C2PC Request Letter

Class II permissive change for **FCC ID: 2AXJ4XE75V2**

Applicant: TP-Link Technologies Co., Ltd.

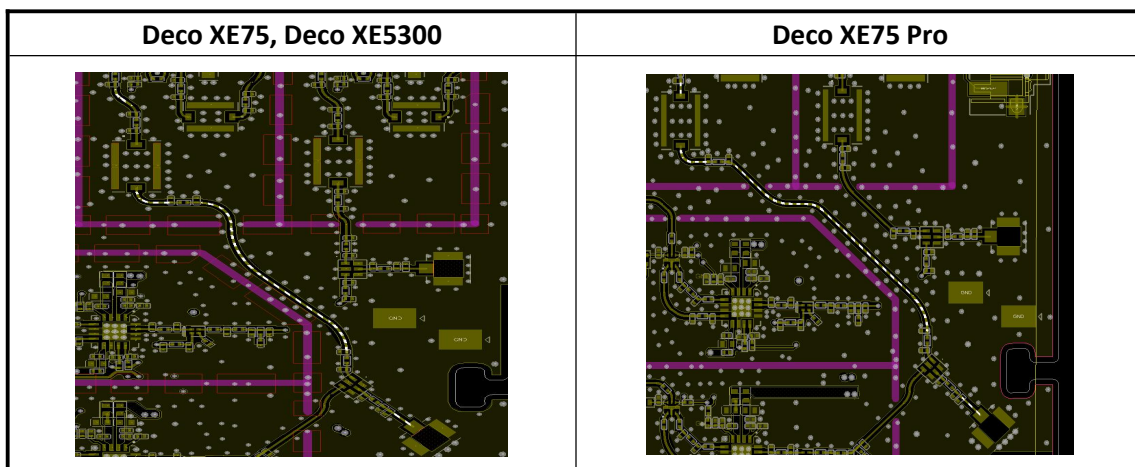
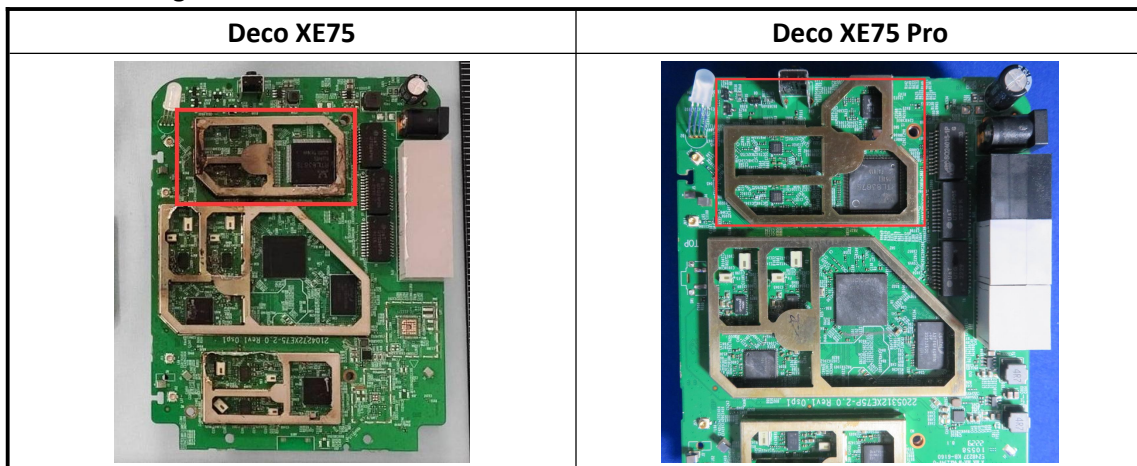
Add “Deco XE75 Pro” in model names, the difference with previous models “Deco XE75,

Deco XE5300” as follows:

1. Ethernet chip is changed.
2. The color and size of RJ45 connector is different.
3. Wi-Fi 5G RF trace is moved.

4. Shielding case of Wi-Fi 2G is different.
